GE HEADQUARTERS PROJECT

BCDC DESIGN SUB-COMMITTEE REVIEW

September 13th, 2016

NECCO STREETScape + ARRIVAL PLAZA

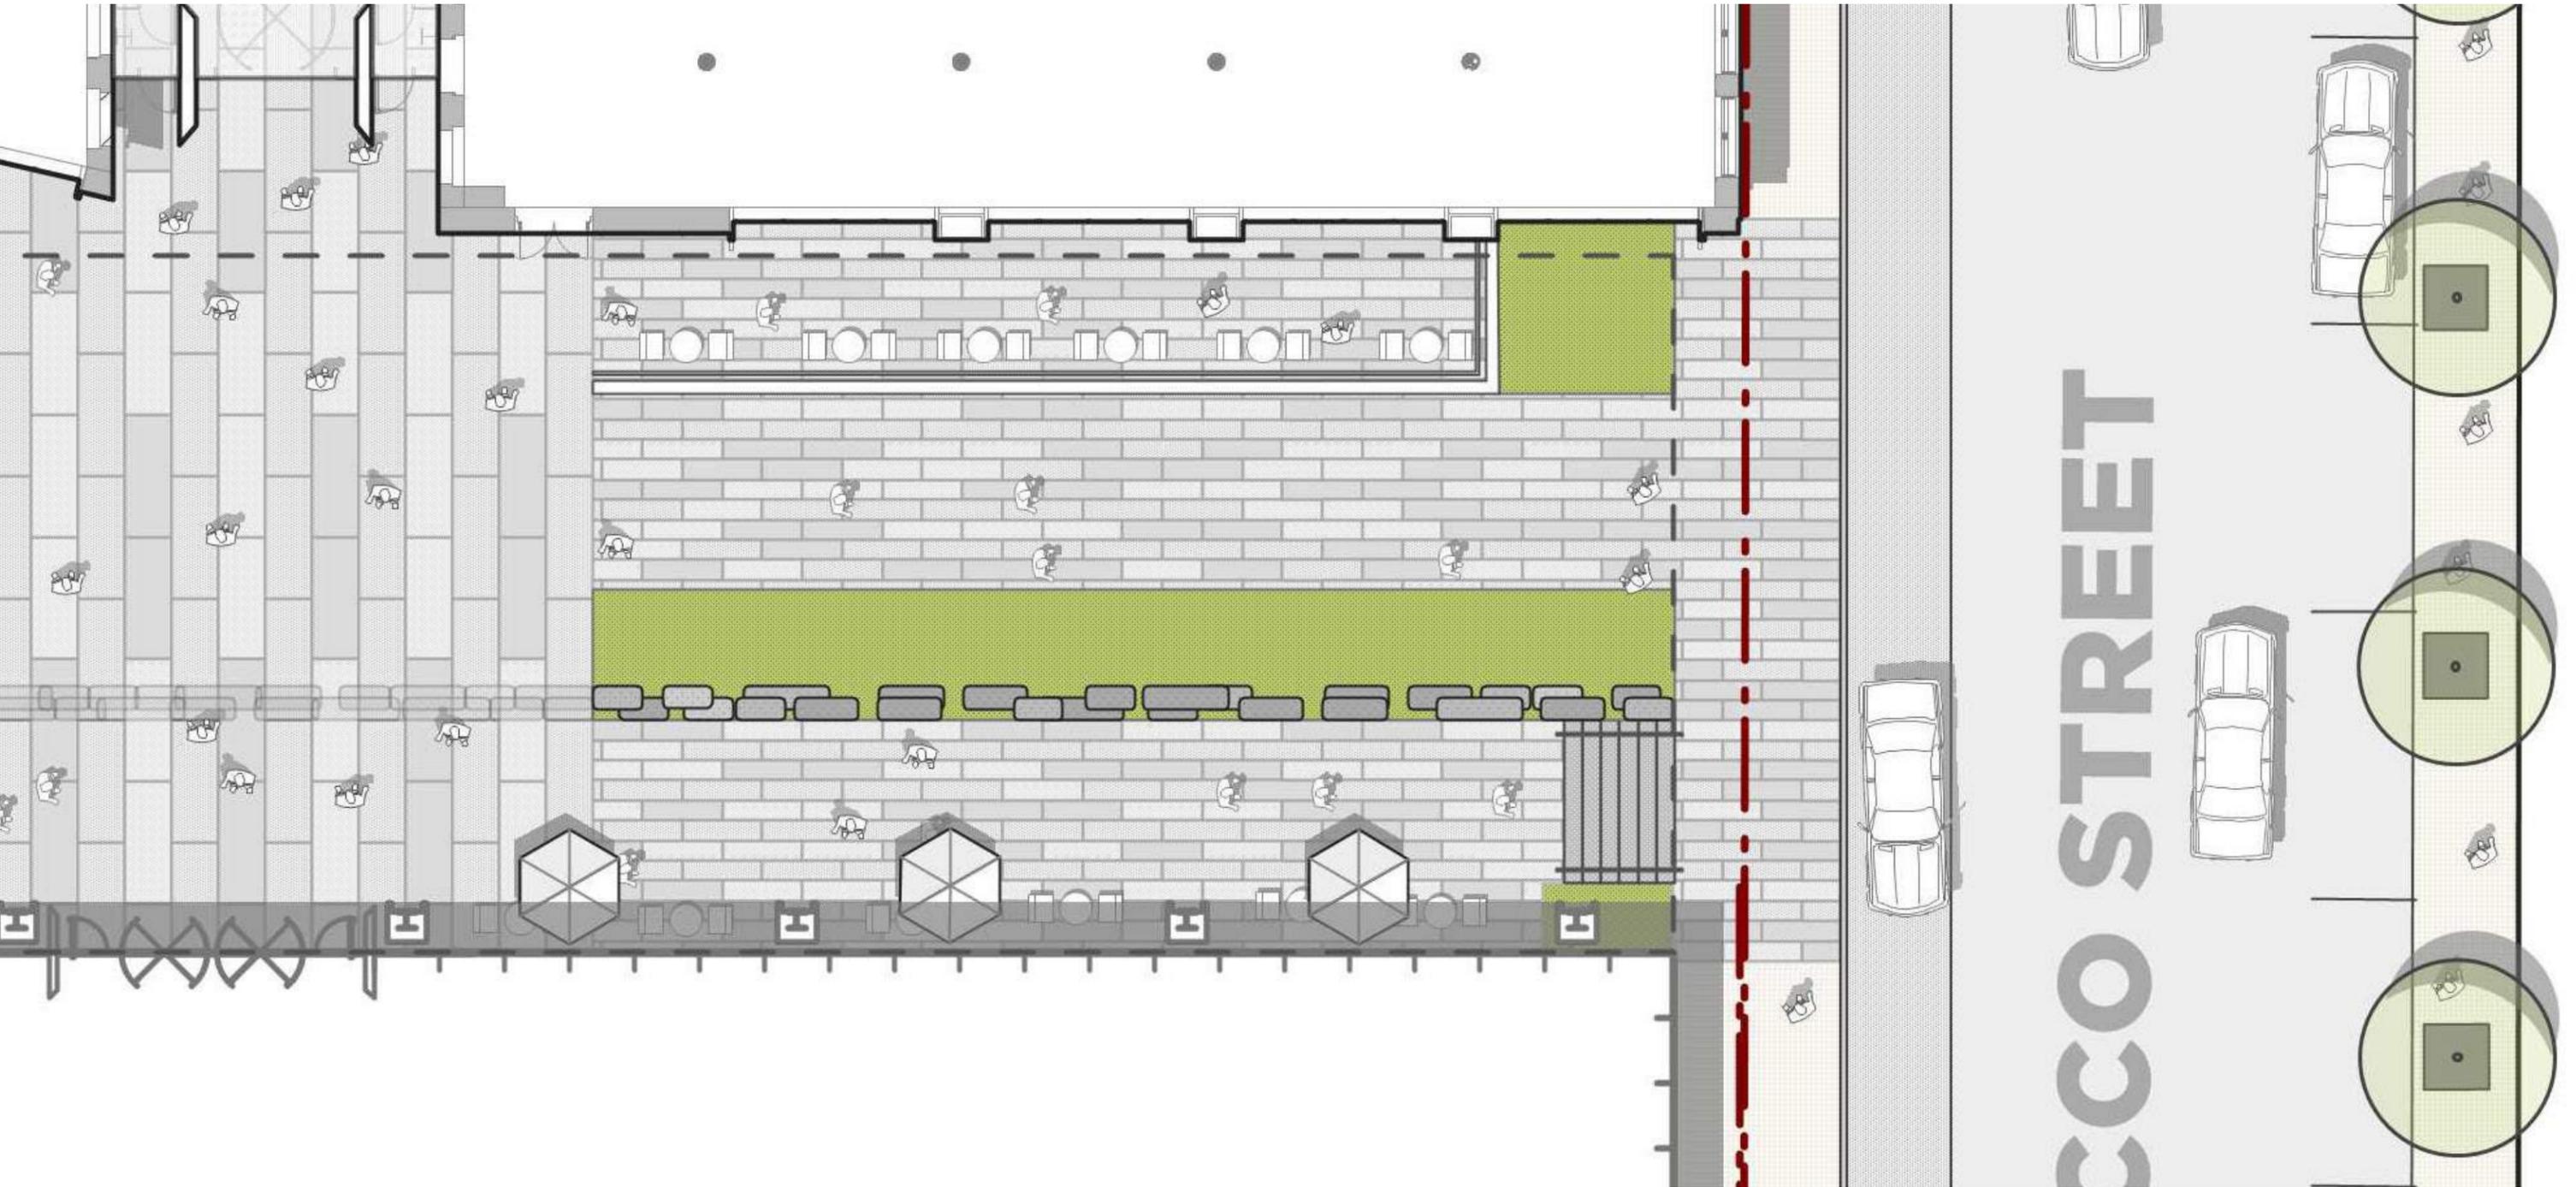
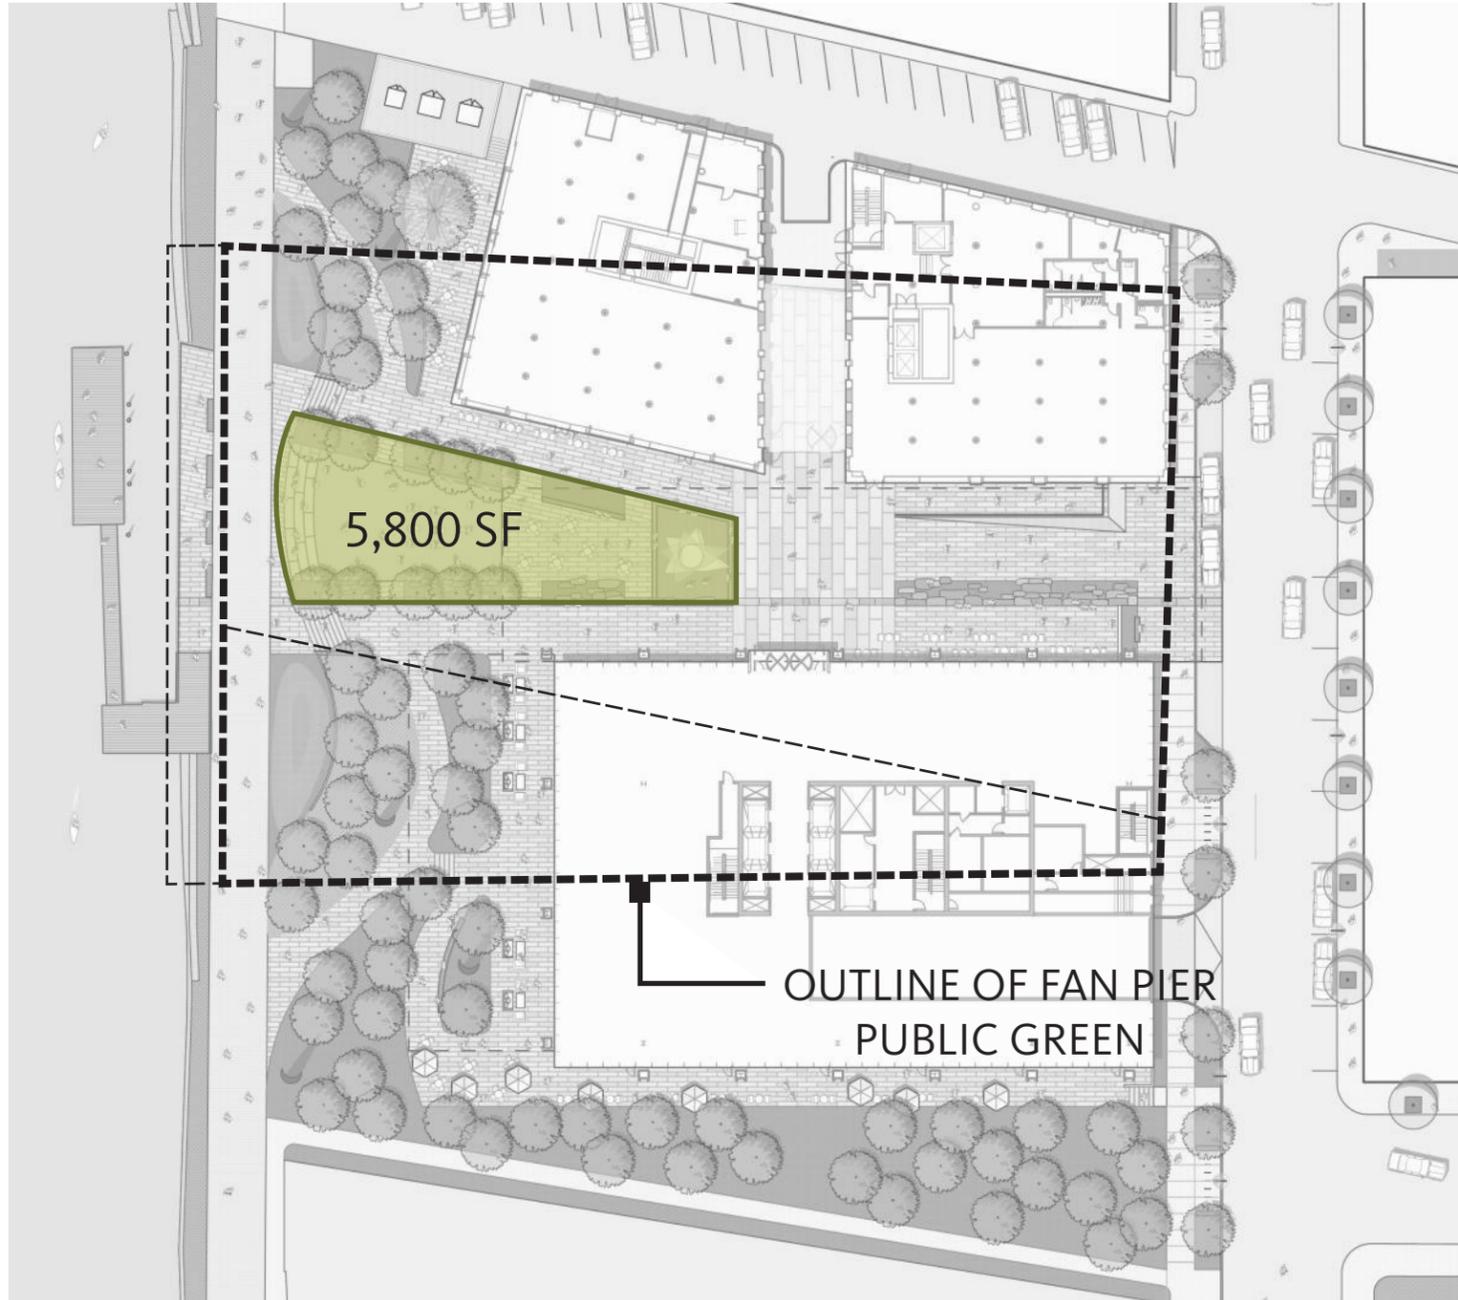
- 1 CREATE A MEANINGFUL ENTRY - NOT A BACK DOOR
- 2 WHAT IS THE PEDESTRIAN EXPERIENCE ON NECCO STREET?
- 3 HOW DO WE ANNOUNCE ENTRY FROM N/S?

- 1 CELEBRATE ENTRY TO GE PLAZA / CREATE A FRONT DOOR
- 2 ENHANCE PEDESTRIAN EXPERIENCE ALONG NECCO ST.
- 3 FRAME VIEW TO ART ON THE PLAZA
- 4 CREATE ENGAGING WALK UP TO PLAZA LEVEL

GE PLAZA + FLEXIBLE EVENT SPACE

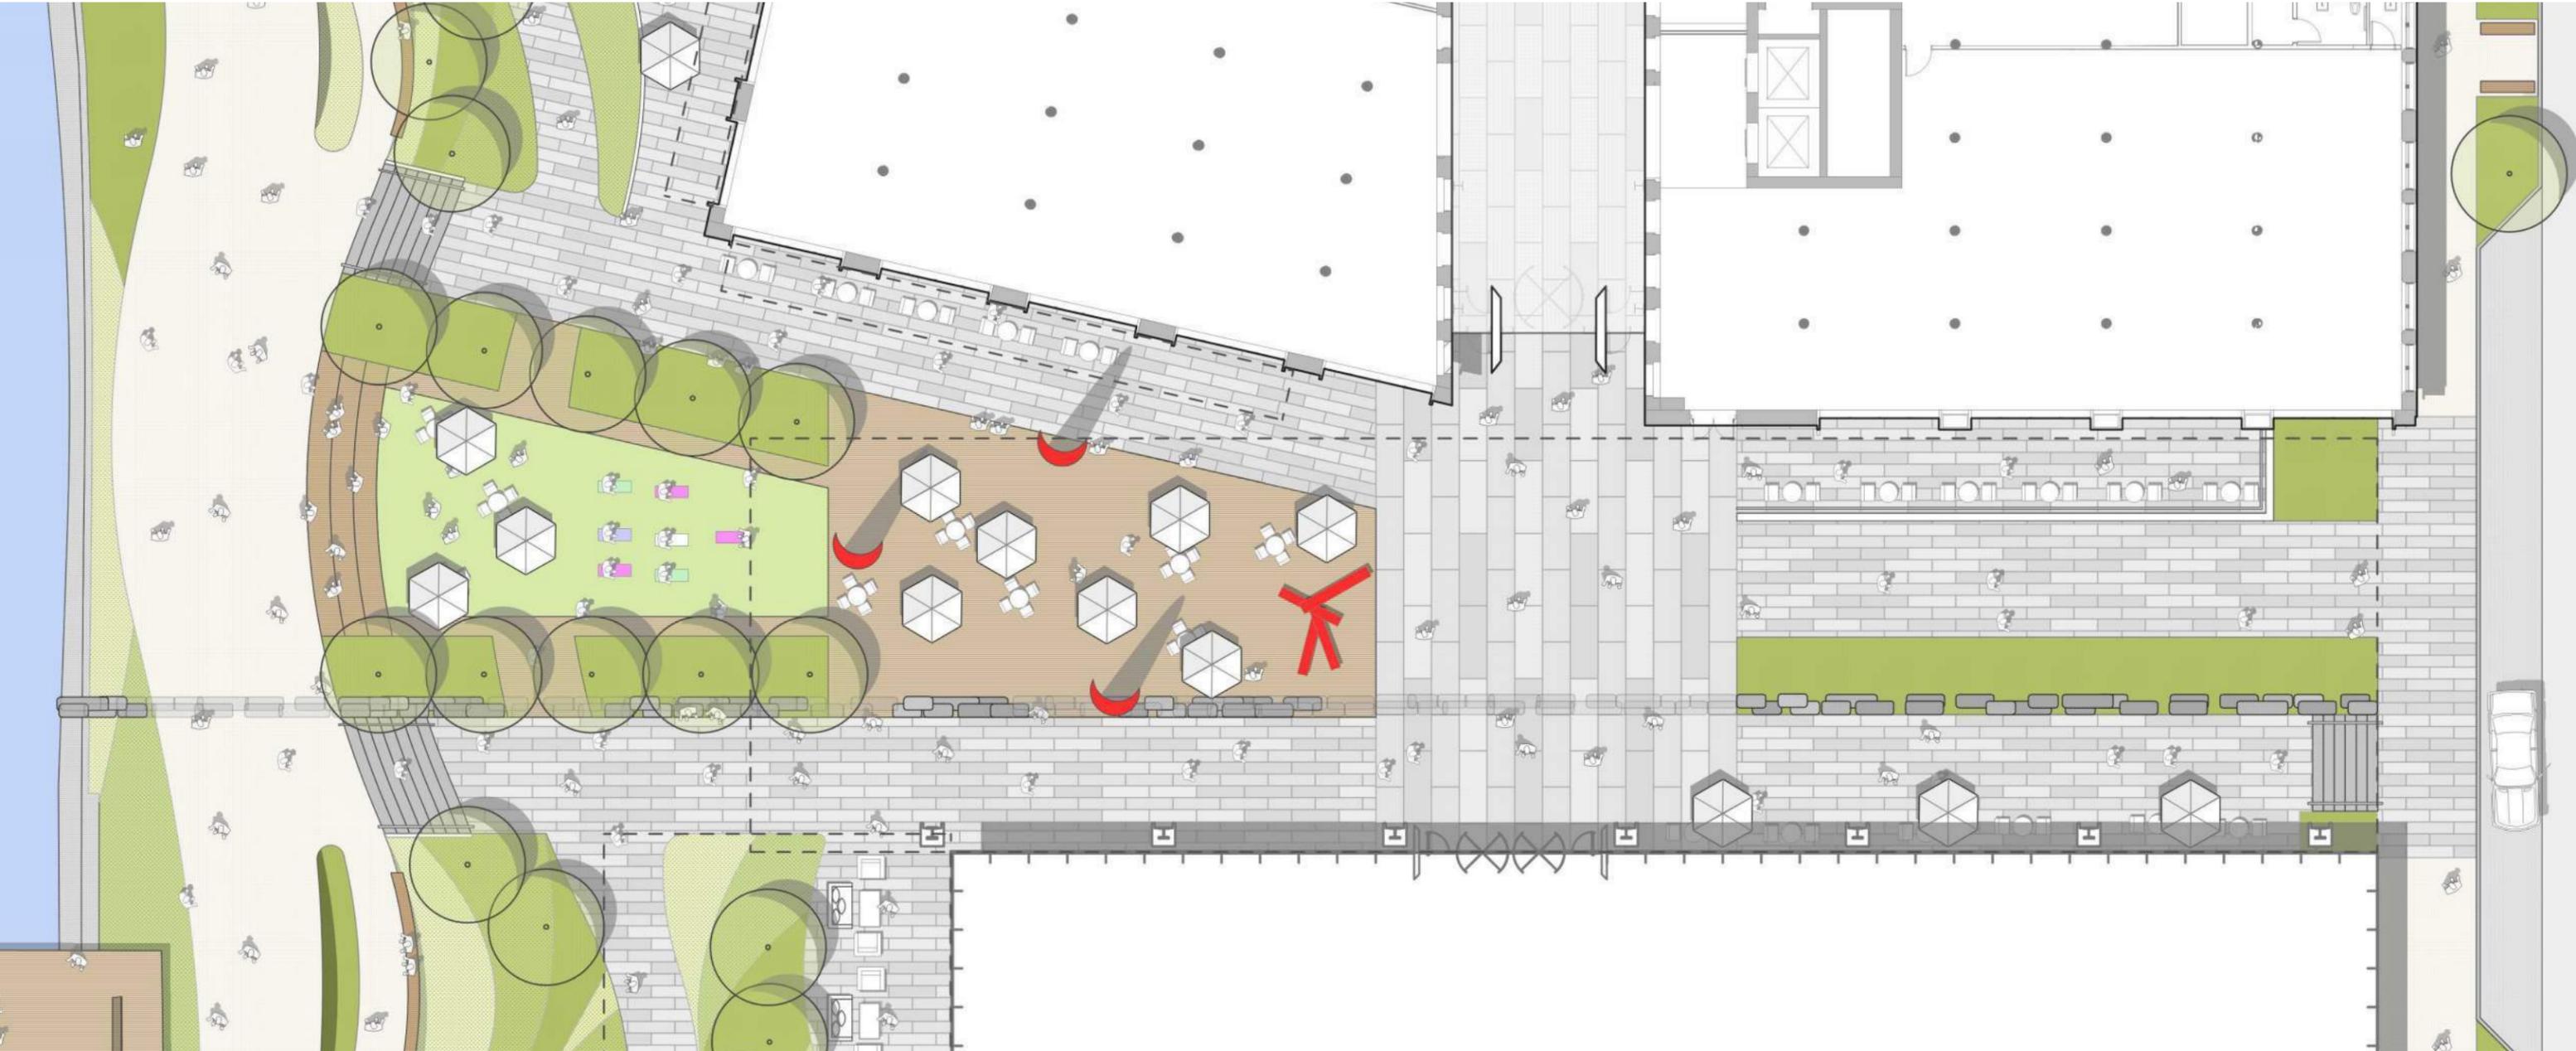
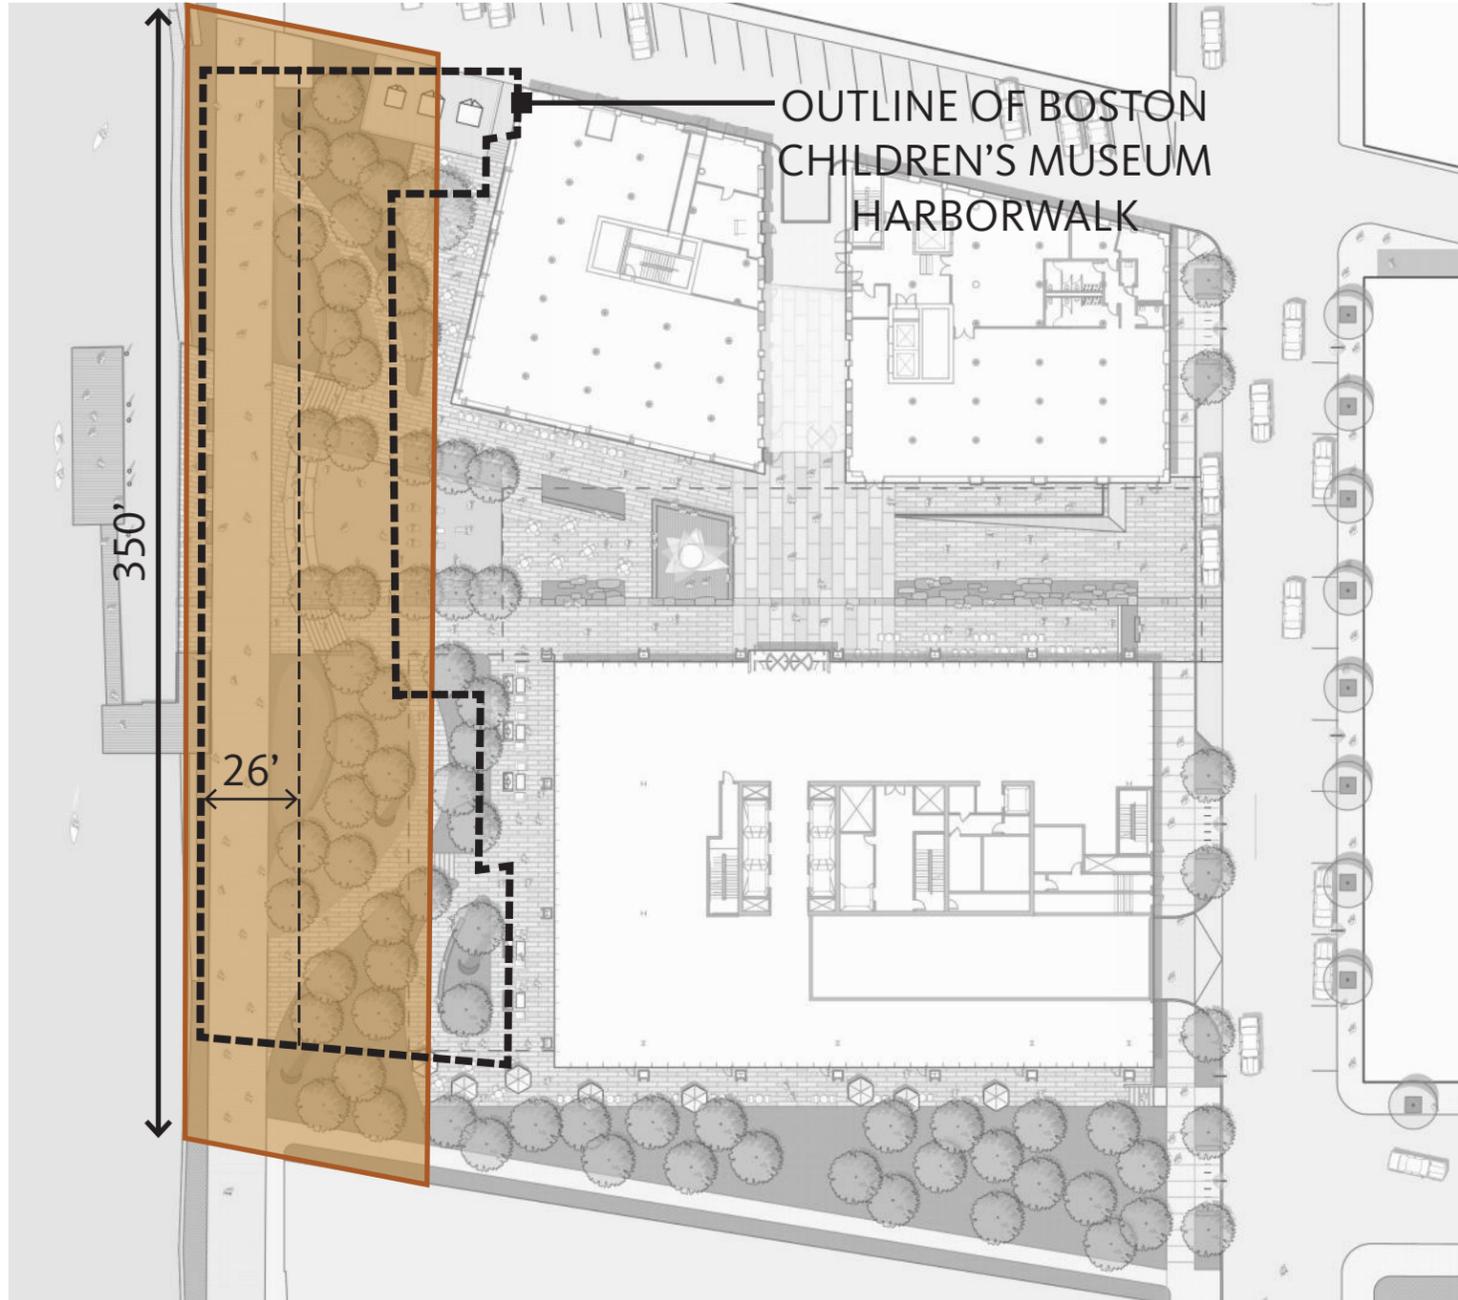
- 1 CONSIDER CREATING PLACE - "A THERE, THERE"
- 2 CONSIDER A SIMPLIFICATION TO PROVIDE CLARITY
- 3 HOW DO VISITORS KNOW THEY HAVE ARRIVED AT GE?
- 4 IS IT A PASSAGEWAY OR A PLACE FOR GATHERING?
- 5 CONSIDER THE "POSTCARD" MOMENT

- 1 CELEBRATE GE IDENTITY
- 2 ALLOW ULTIMATE FLEXIBILITY FOR VARIETY OF USES
- 3 CONNECT FROM NECCO STREET TO THE CHANNEL
- 4 CREATE BETTER CONNECTION TO EXISTING DOCK
